**MICROCHIP****PIC18F2420/2520/4420/4520****PIC18F2420/2520/4420/4520 Rev. B4 Silicon Errata**

The PIC18F2420/2520/4420/4520 Rev. B4 parts you have received conform functionally to the Device Data Sheet (DS39631E), except for the anomalies described below. Any Data Sheet Clarification issues related to the PIC18F2420/2520/4420/4520 will be reported in a separate Data Sheet errata. Please check the Microchip web site for any existing issues.

The following silicon errata apply only to PIC18F2420/2520/4420/4520 devices with these Device/Revision IDs:

FIGURE 1: SCK PULSE VARIATION USING TIMER2/2**Work around**

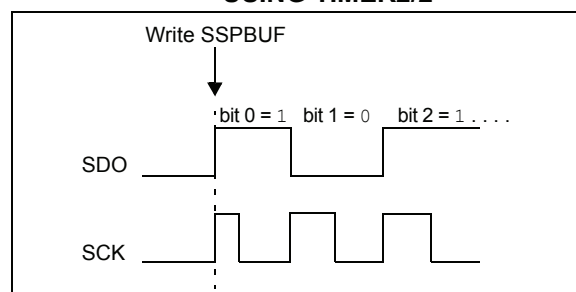
When the SPI is using Timer2/2 as the clock source, a shorter than expected SCK pulse may occur on the first bit of the transmitted/received data (Figure 1).

To avoid producing the short pulse, turn off Timer2 and clear the TMR2 register, load the SSPBUF with the data to transmit and then turn Timer2 back on. Refer to Example 1 for sample code.
